Project Minutes

Project: New Stoneham High School
 Prepared by: Mark Stafford
 Re: School Building Committee Meeting
 Location: Central Middle School Media Center and
 Remote Participation
 Distribution: Attendees (MF)

Project No.: 20033
 Meeting Date: 8/22/2022
 Time: 7:00pm
 Meeting No: 54

Materials and Layout
L-02 Part B

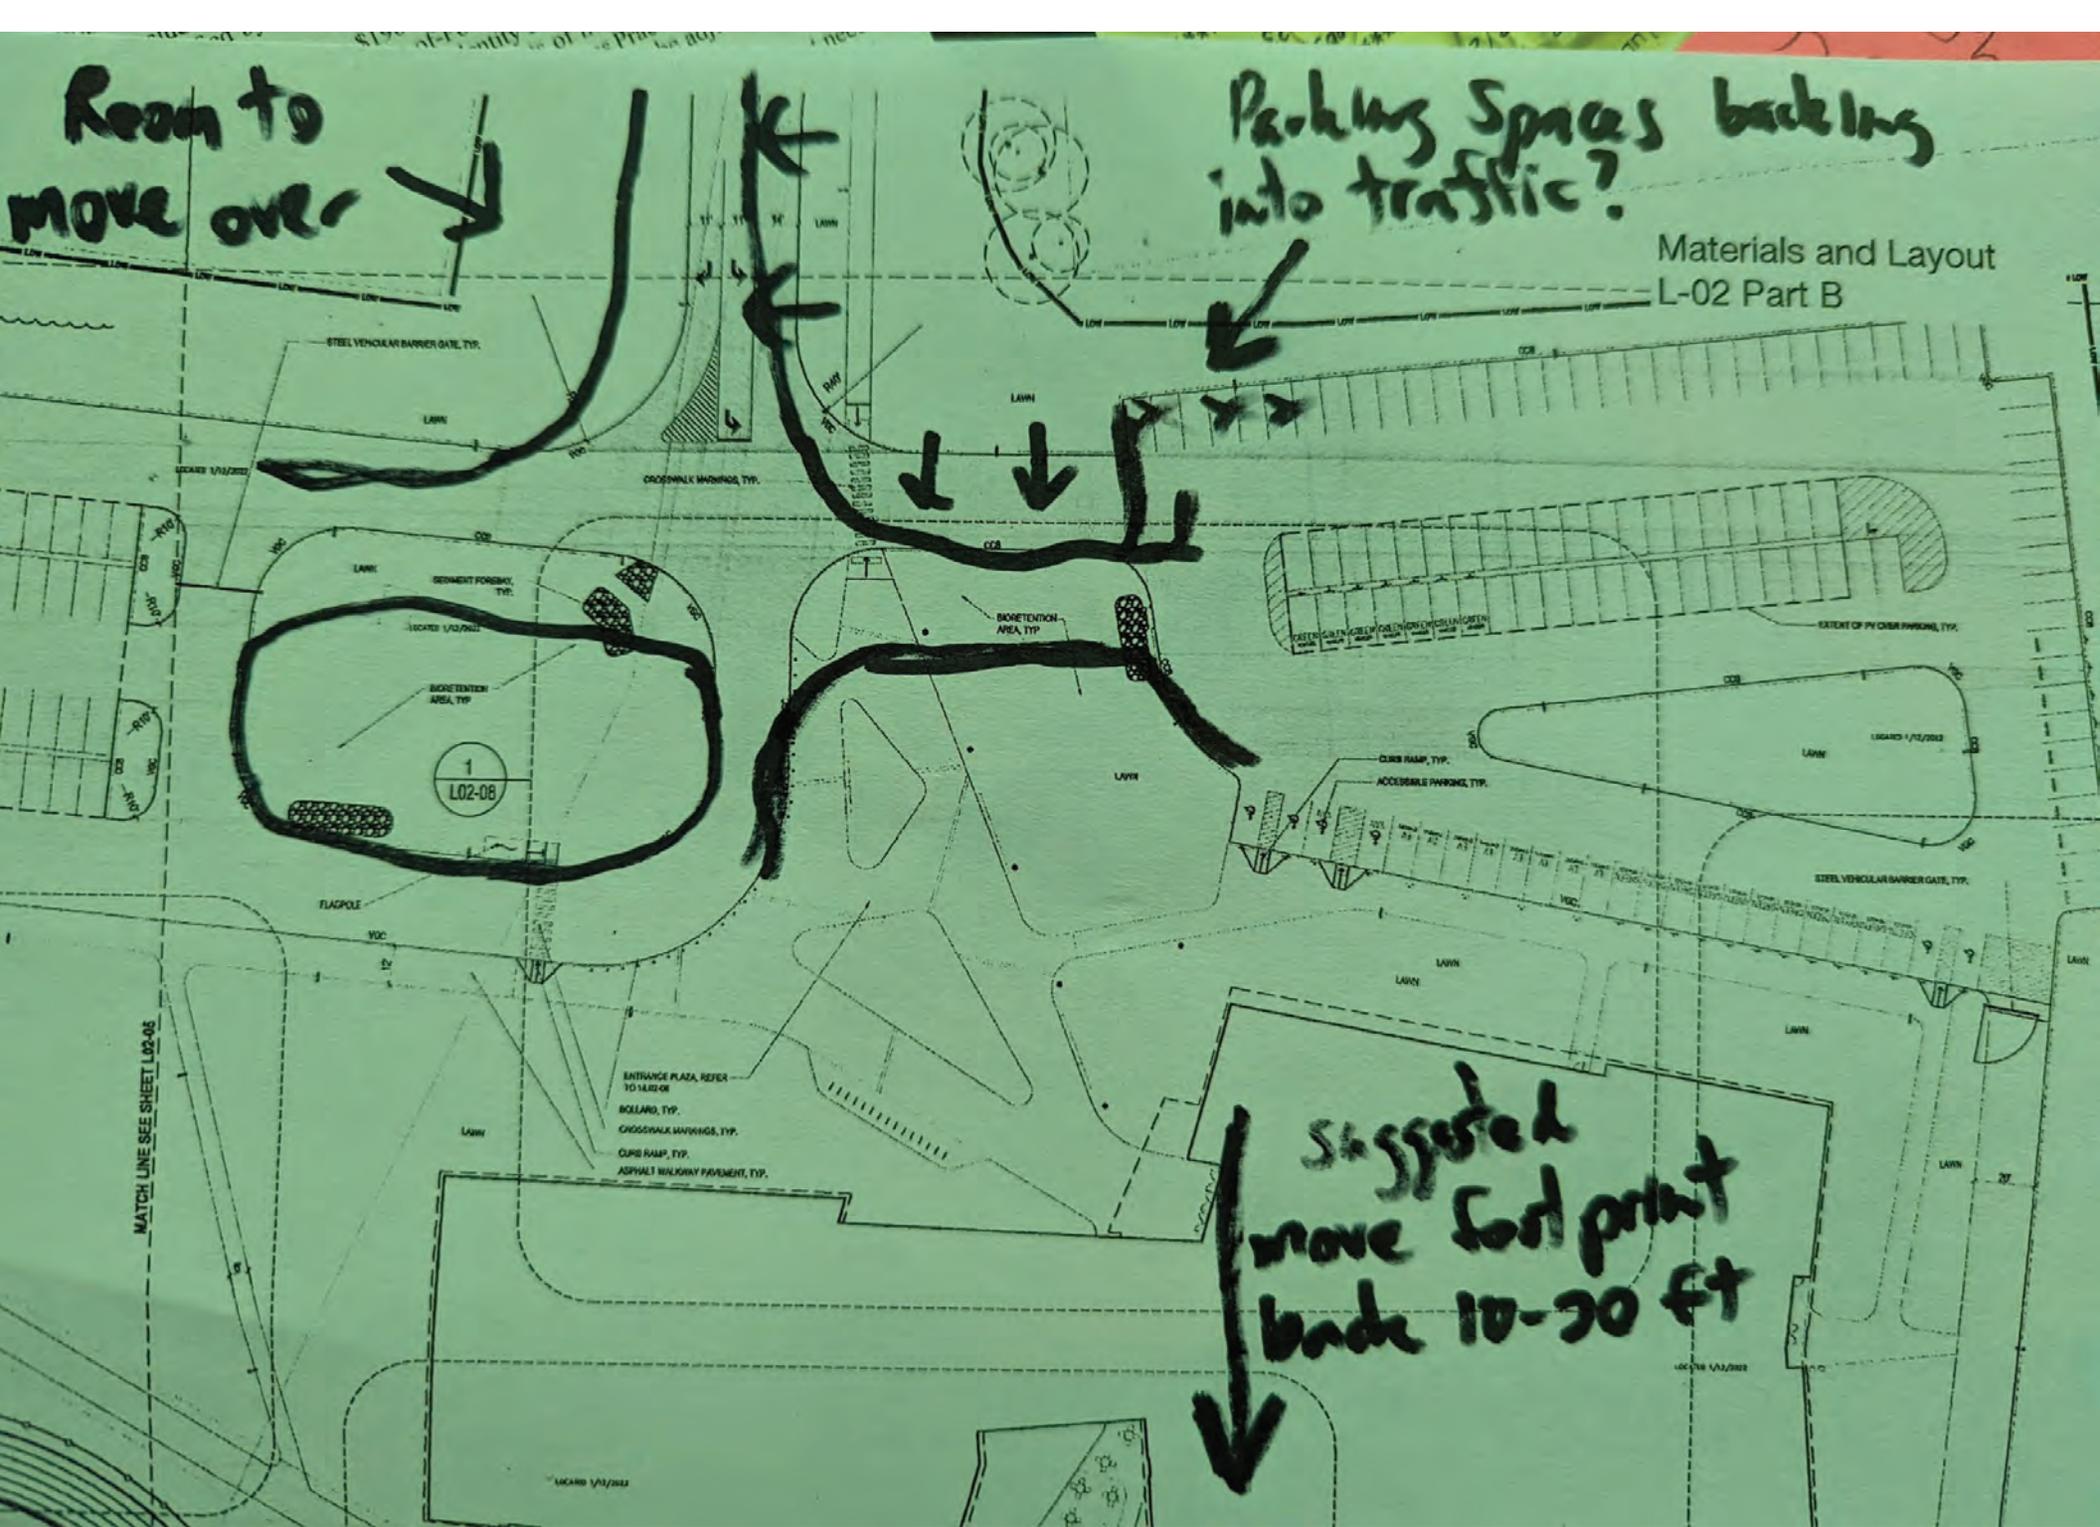
Room to
move over

Parking Spaces backing
into traffic?

suggested
move footprint
back 10-20 ft
